TOWN OF WELLS, MAINE
PLANNING BOARD

Meeting Agenda
Monday, February 23, 2026, 7:00 PM
Littlefield Meeting Room, Town Hall
208 Sanford Road

To: Planning Board

Sheet No.: C2.0

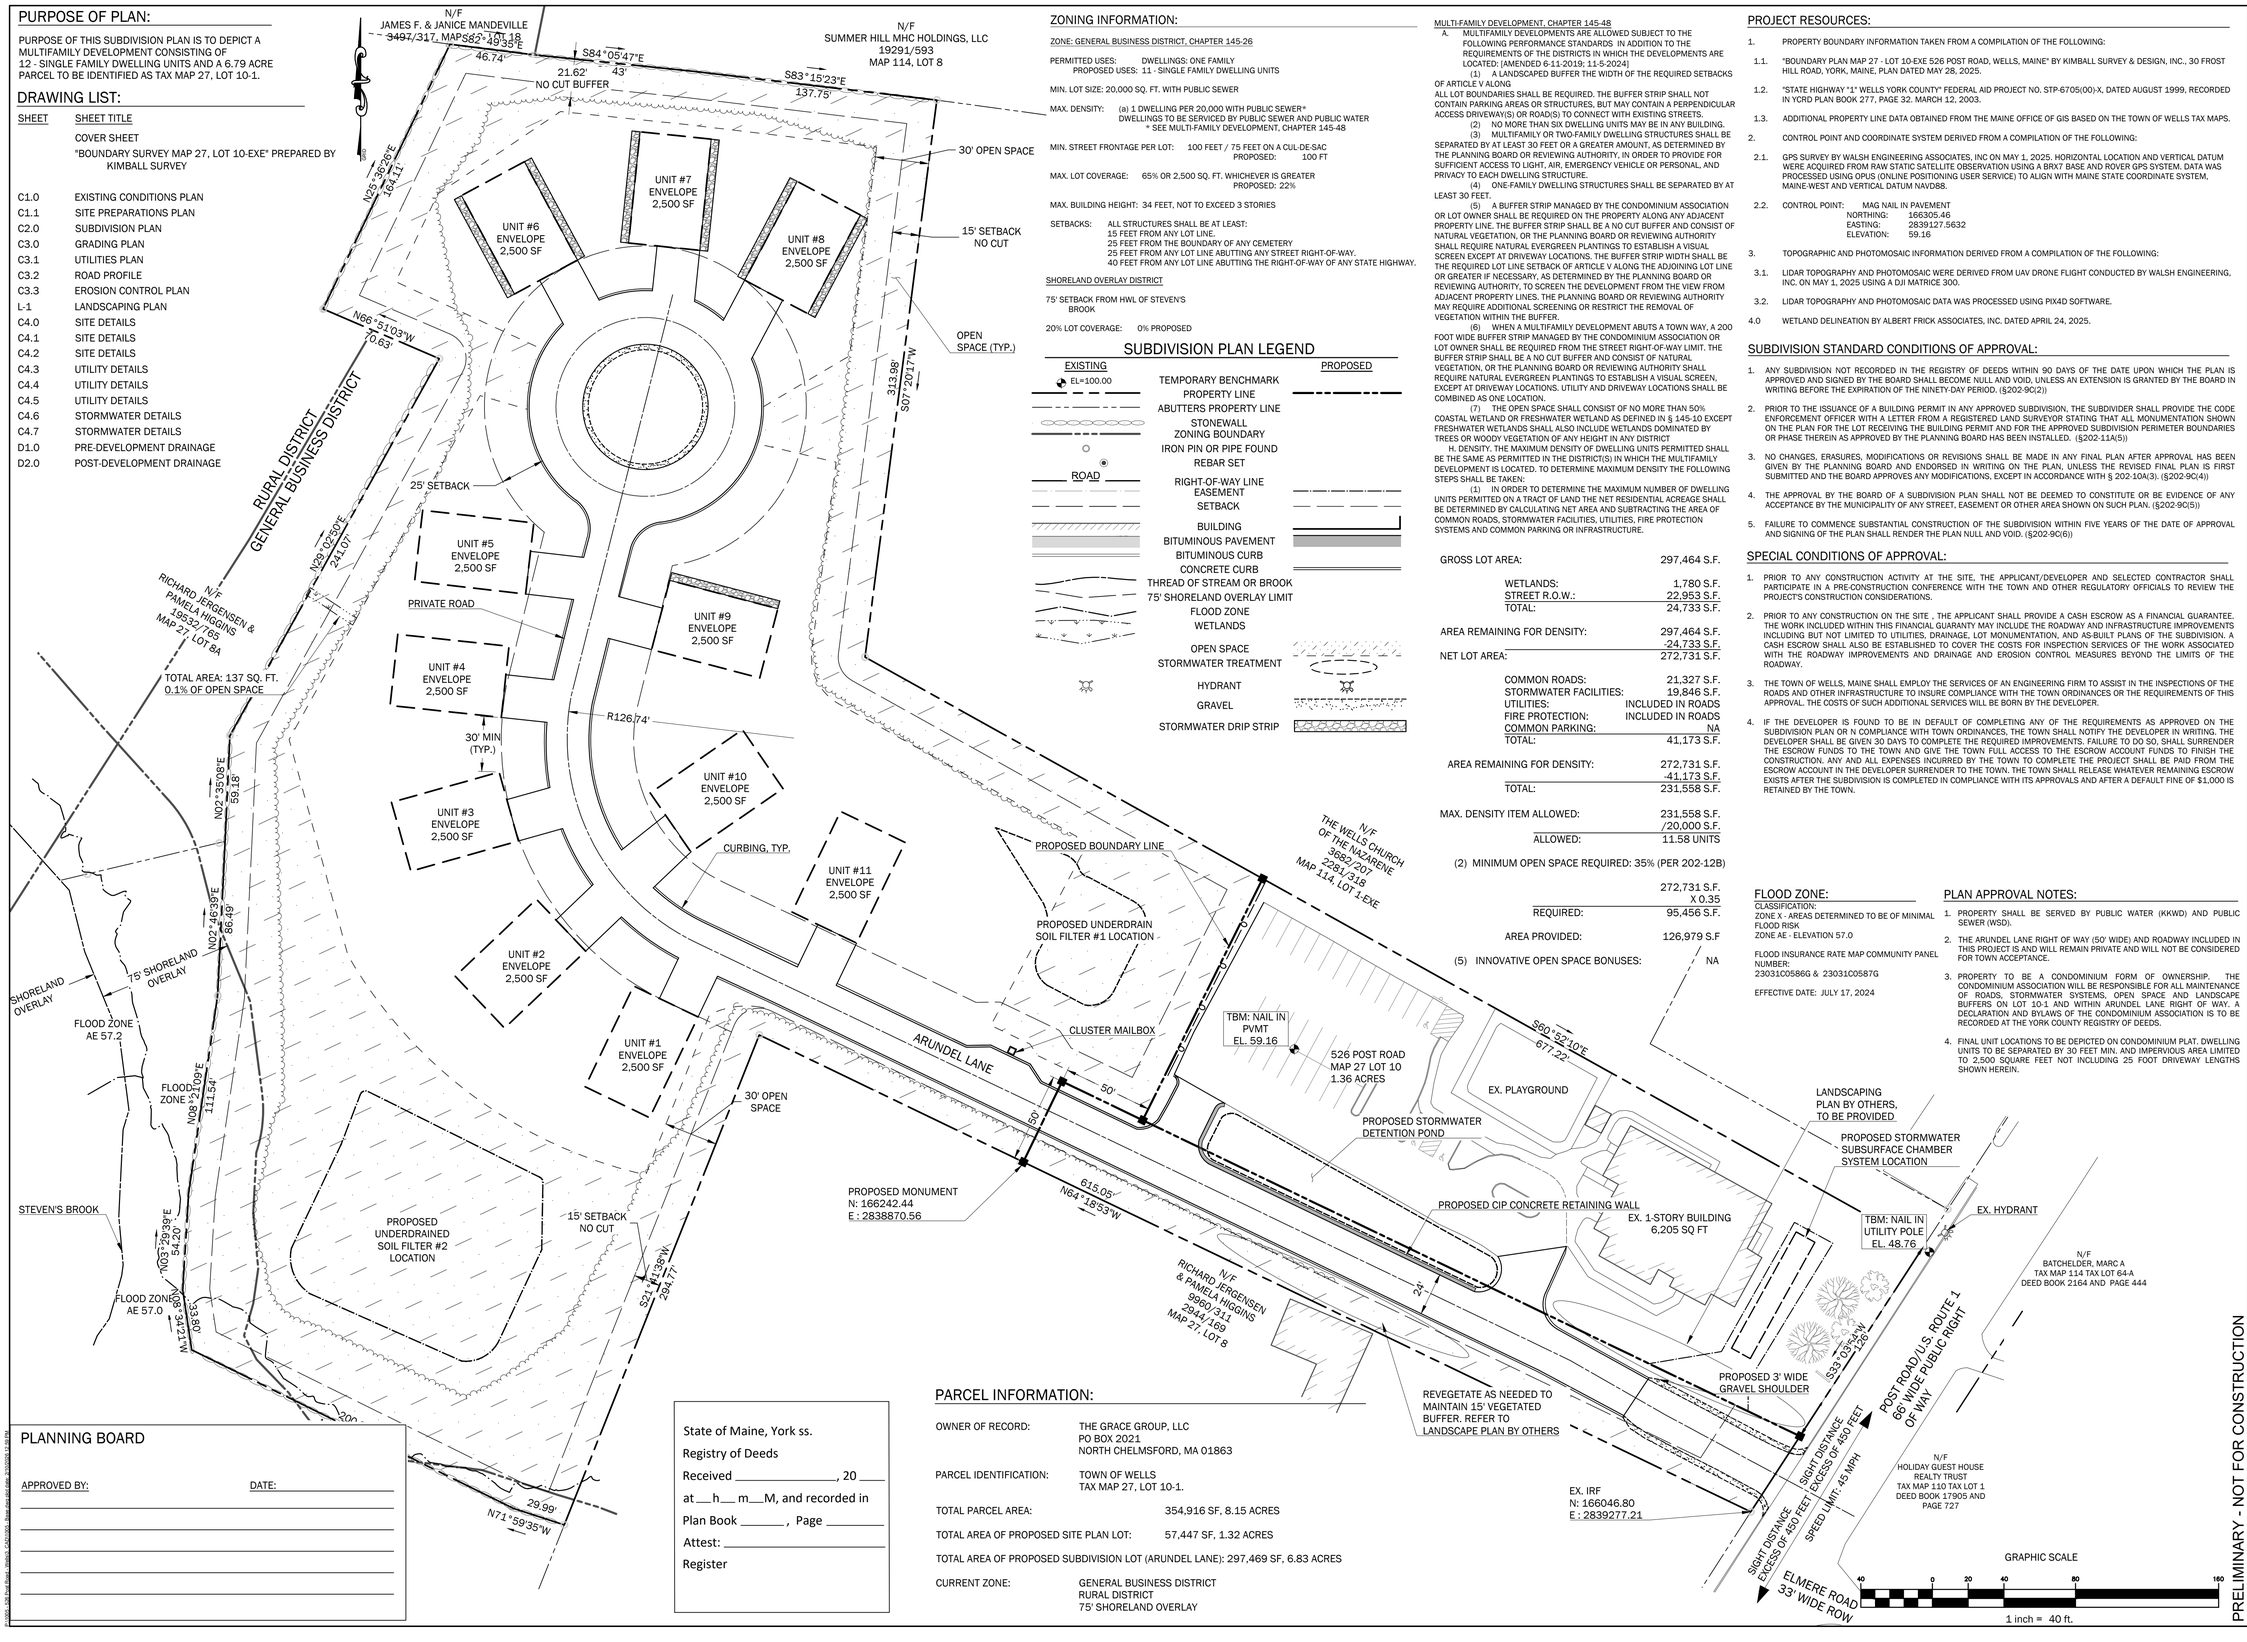
F.(6).a. [3]	Twenty-five feet from any lot line abutting any street right-of-way.	**Parcel does abut the Arundel Lane ROW. 25' setback to be identified.**	Y	C2.0	Proposed 25' setback off of Arundel Lane ROW has been added.
145-48	**PERFORMANCE STANDARDS - MULTIFAMILY DEVELOPMENTS**				
A.(1)	A landscaped buffer the width of the required setbacks of Article V along all lot boundaries shall be required. The buffer strip shall not contain parking areas or structures, but may contain a perpendicular access driveway(s) or road(s) to connect with existing streets	15' wide landscaped buffer along all lot lines noted. **Label corrections needed.** Arundel Lane roadway serving the multifamily development crosses the buffer required from the street ROW.	Y	All Sheets	Labels for the proposed 15' landscaped buffers for the multifamily development have been updated accordingly on all sheets.
A.(4)	One-family dwelling structures shall be separated by at least 30 feet.	**Single family dwellings shall be separated by a minimum of 30 feet. Measurements between the units on the plan appear to be 28 or 29', not 30'.** **Plan provided is not to scale.**	Y	All Sheets	Confirmation that all building envelopes are separated by 30 feet. Plans have been printed with correct margins to provide accurate scale.

SHEET C-103

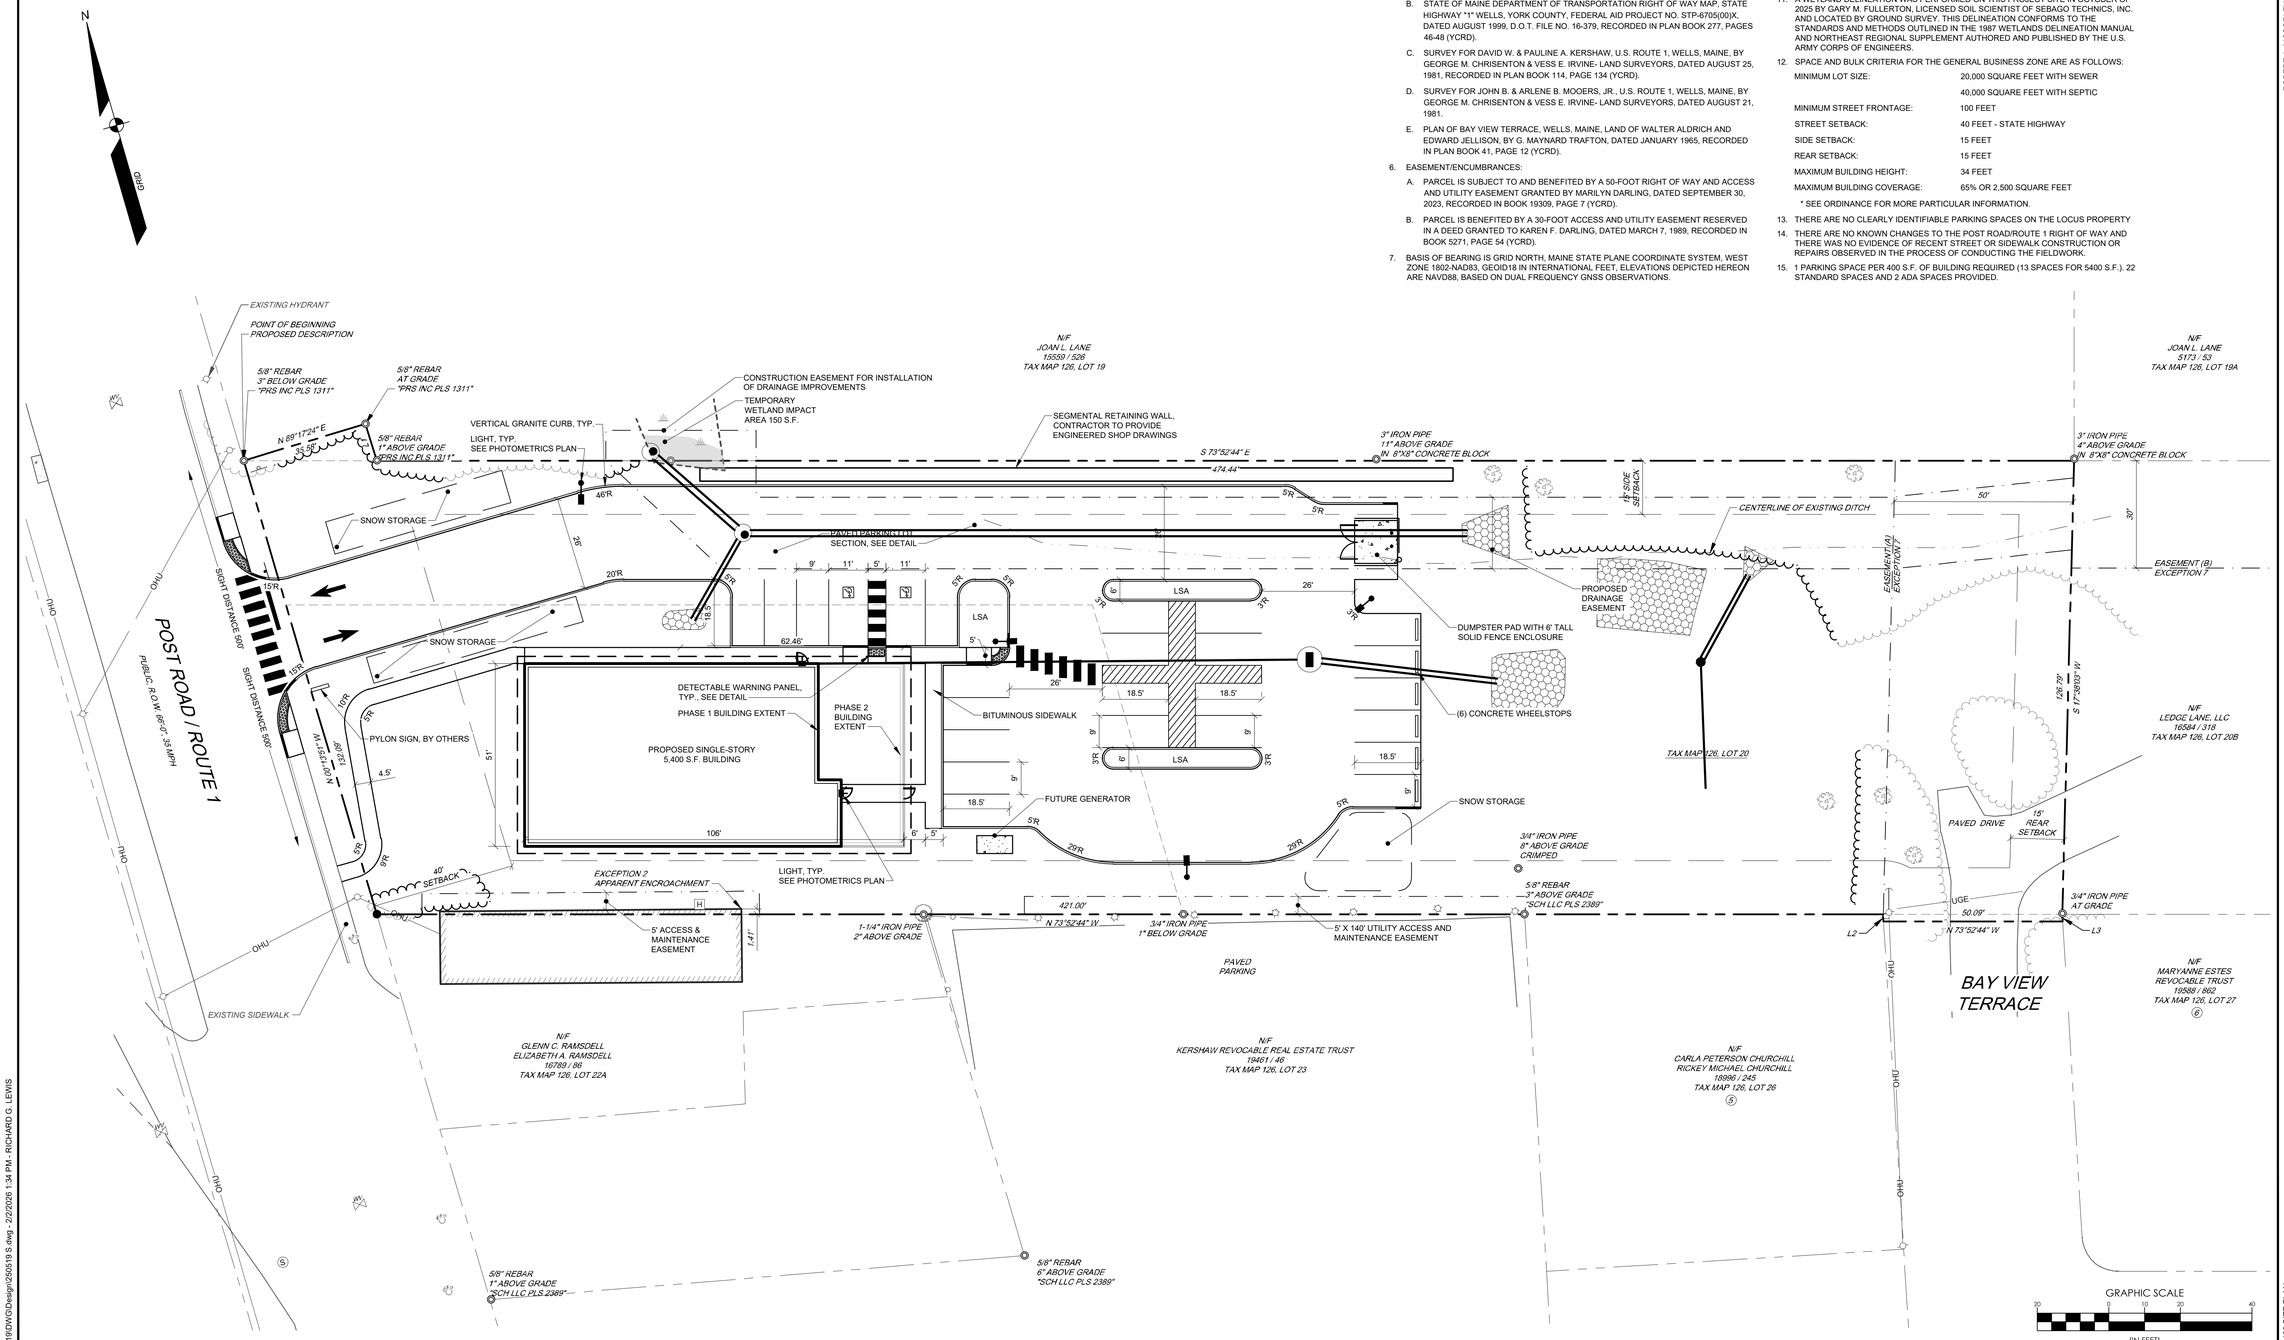
e. A 15 foot wide landscaped buffer is required along Route 1. Sheet L-101 depicts the proposed landscaping. Two birch trees are proposed near the 15' wide landscaped buffer and need to be adjusted to fall within the buffer. Birch trees are required to have a 3" diameter at breast height. Plan updates needed. Buffer determination to be made after the public hearing is considered.
